REVISED COMMENTS

CADIZ GROUNDWATER STORAGE PROJECT
CADIZ AND FENNER VALLEYS
SAN BERNARDINO COUNTY, CALIFORNIA

PREPARED FOR: WESTERN ENVIRONMENTAL LAW CENTER
TAOS, NEW MEXICO

JOHN BREDEHOEFT, PH.D.
AUGUST 2001

Figure 1. Hypothetical schedule of pumping and recharge.

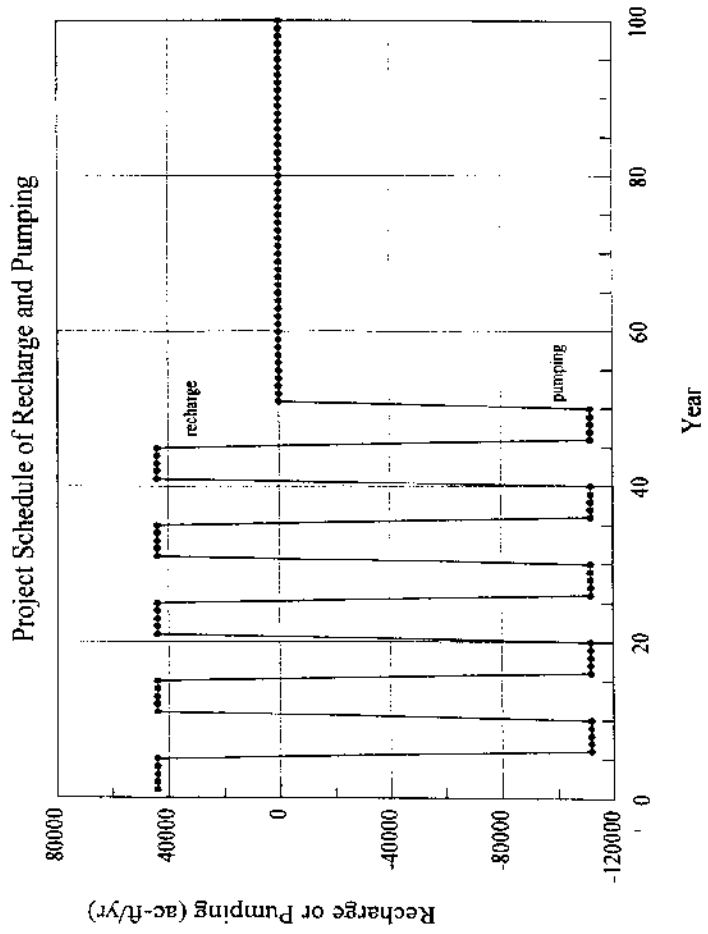
Using a groundwater flow model I projected the drawdown at several observation wells to illustrate the point about the difficulty associated with monitoring and control of the Cadiz Project. In order to do the modeling one has to assume some schedule of project operations. My assumed schedule of recharge and pumping is shown in Figure 1. Figure 2 is a map showing selected hypothetical observation well locations. Figure 3 shows the model-projected hydrographs for the three hypothetical well locations.

Figure 3. Computed drawdown in three hypothetical observation wells.

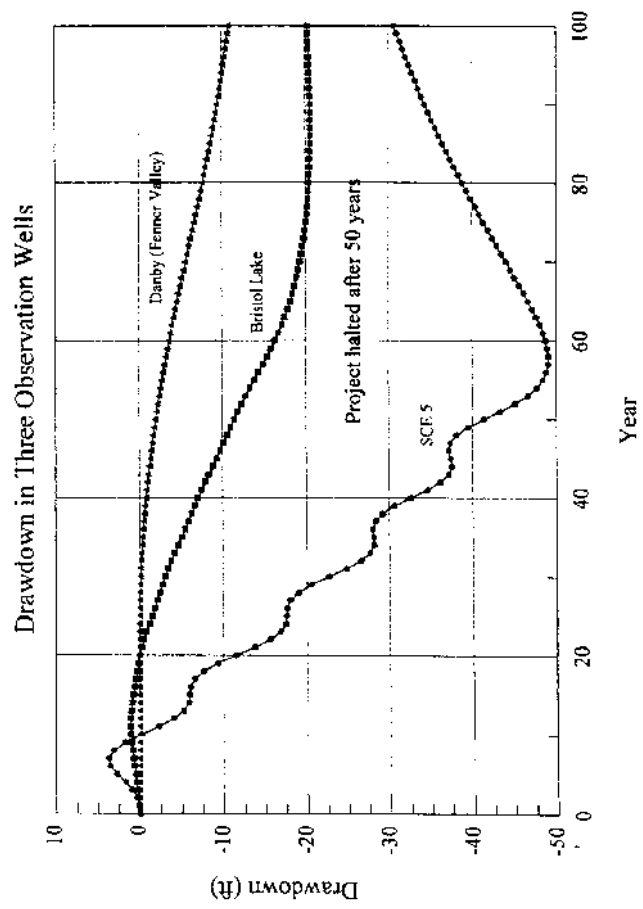
Consider for example the drawdown in Fenner Valley as observed in the observation well near Danby—see Figures 2 and 3. This well has almost no drawdown in 40 years of project operation. The drawdown is approximately 3 feet in 50 years, but this is only the beginning. The drawdown is 10 feet in 100 years, 50 years after the project was shut

down, and the drawdown at Danby is continuing to decline. At 100 years the drawdown is continuing to migrate up Fenner Valley to the north even though the pumping was totally stopped 50 years earlier.

The monitoring situation is a bit clearer beneath Bristol Lake—see Figure 3. There is no decline in the water table beneath the center of the lake out to 20 years. By 30 years the drawdown is approximately 7 feet and by 50 years it is approximately 12 feet. Again this is only the beginning, the drawdown goes to 20 feet in 80 years and remains at 20 feet to 100 years. Even though the project was stopped after year 50, there is no recovery in water levels beneath the lake in 100 years.

Figure 4. Computed plot of TDS in observation well SCE 5.

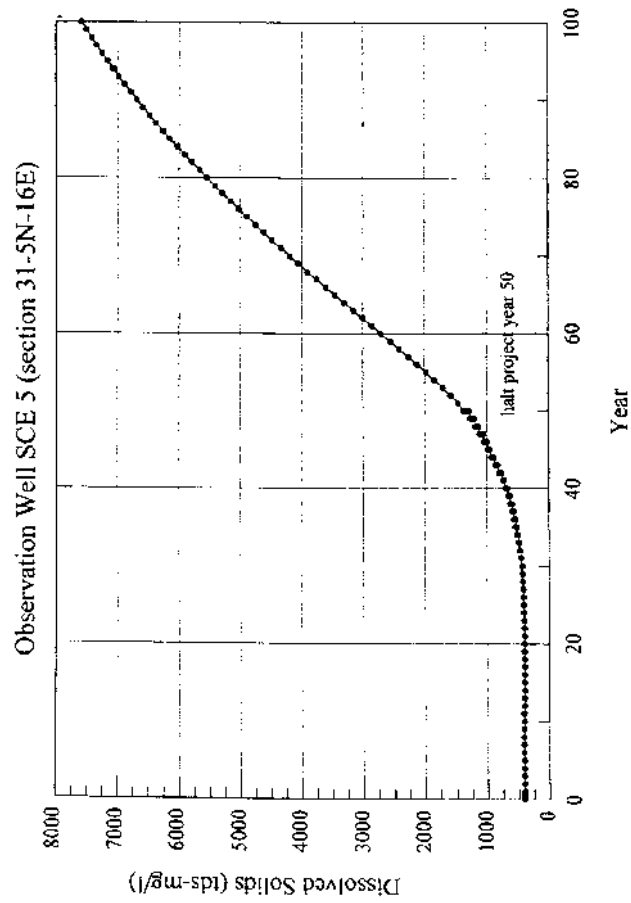
I ran a groundwater transport model to simulate the movement of the brine beneath Bristol Lake. Observation well SCE 5 is situated approximately halfway from the proposed project and Bristol Lake playa—see Figure 2. The total dissolved solids, as observed in this observation well, are plotted in Figure 4. Notice that the dissolved solids start to increase slightly in year 30. By year 45 it increases to 1,000 milligrams per liter (mg/l); by year 50 the concentration is 1,300 mg/l. This water is still useable; but again this is only the beginning. The concentration increases to more than 7,500 mg/l by 100 years, and it is still increasing—again the project was halted 50 years earlier.

The point shown especially by the brine movement is that we would have to halt the pumping of native groundwater very early on in order for there not to be a significant degradation in water quality at this location. I selected only one location to make my point, but this is not an isolated location; the degradation in water quality between Bristol Lake and the project will be widespread and continuing out to at least 100 years. The groundwater flow into the cone of depression will still be significant at 100 years. The groundwater flow from the region of Bristol Lake will bring with it brine from beneath the lake. The outward flow of brine will render the groundwater unusable without costly treatment. The modeling suggests an area more than 10 square miles will be impacted.
